FIGURE 3.1-1  
MINIMUM BORATED WATER VOLUMES

### 3/4.6.3 CONTAINMENT ISOLATION VALVES

### 3/4.8.4 ELECTRICAL EQUIPMENT PROTECTIVE DEVICES

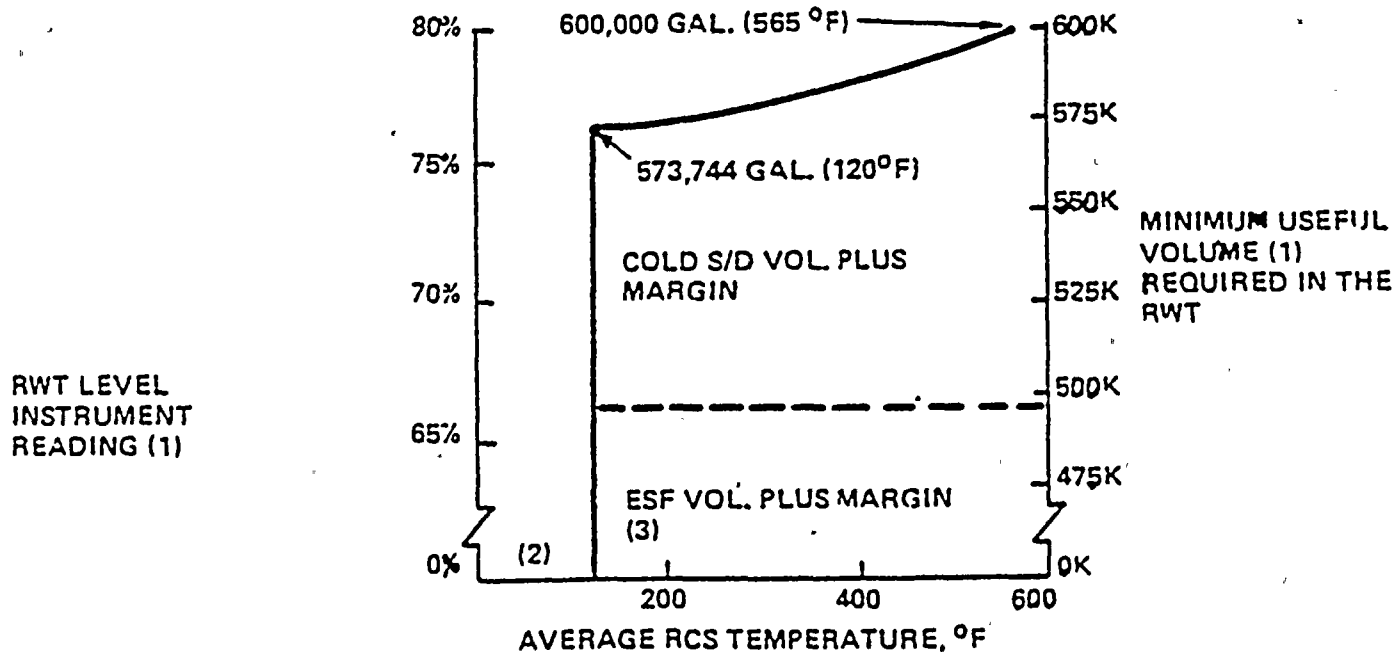
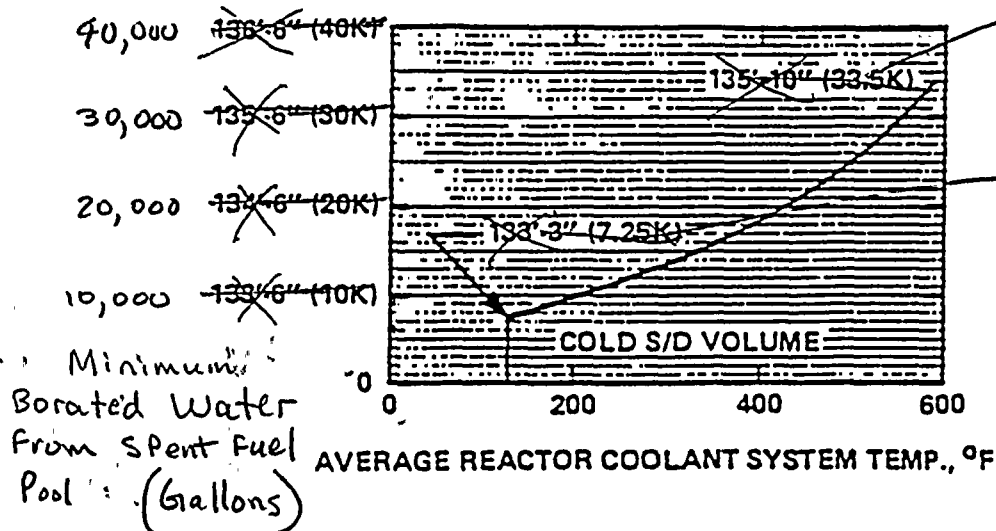
- (1) THE TANK LEVEL AND VOLUME SHOWN ARE THE USEFUL LEVEL AND VOLUME ABOVE THAT IN THE TANK WHICH IS REQUIRED FOR VORTEX CONSIDERATIONS
- (2) DURING MODE 5 AND 6 ONE OF THESE BORATED SOURCES SHALL CONTAIN A MINIMUM OF 33,500 GALLONS
- (3) THIS VOLUME IS NOT REQUIRED DURING MODE 6

FIGURE 3.1-1  
MINIMUM BORATED WATER VOLUMES

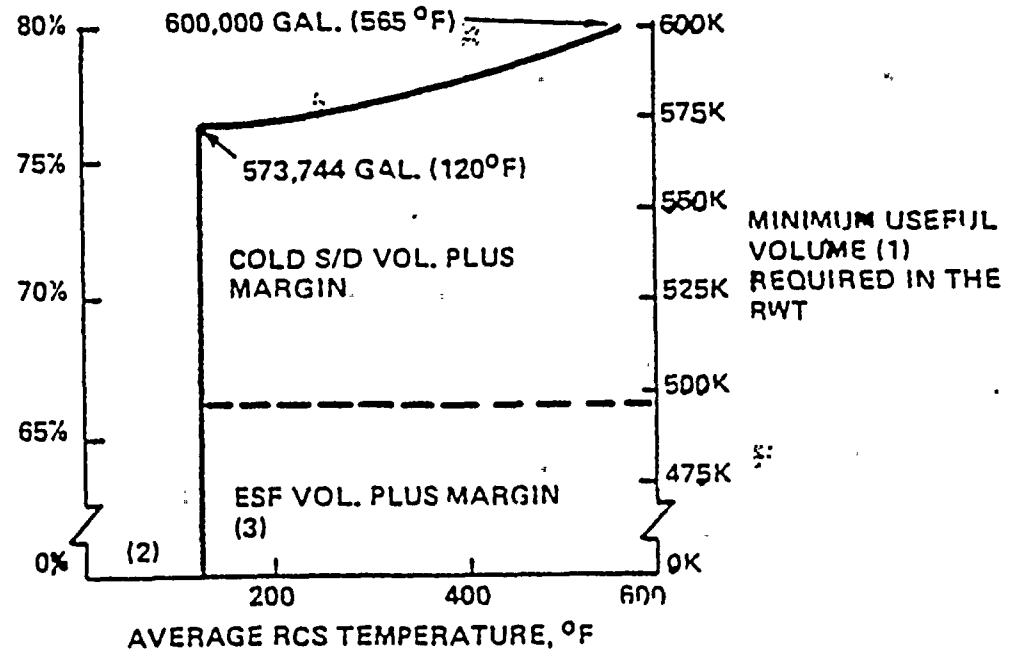
- (1) The tank level and volume shown are the useful level and volume above that in the tank which is required for vortex considerations
- (2) During Mode 5 and 6, one of these borated sources shall contain a minimum of 33,500 gallons
- (3) This volume is not required during Mode 6.
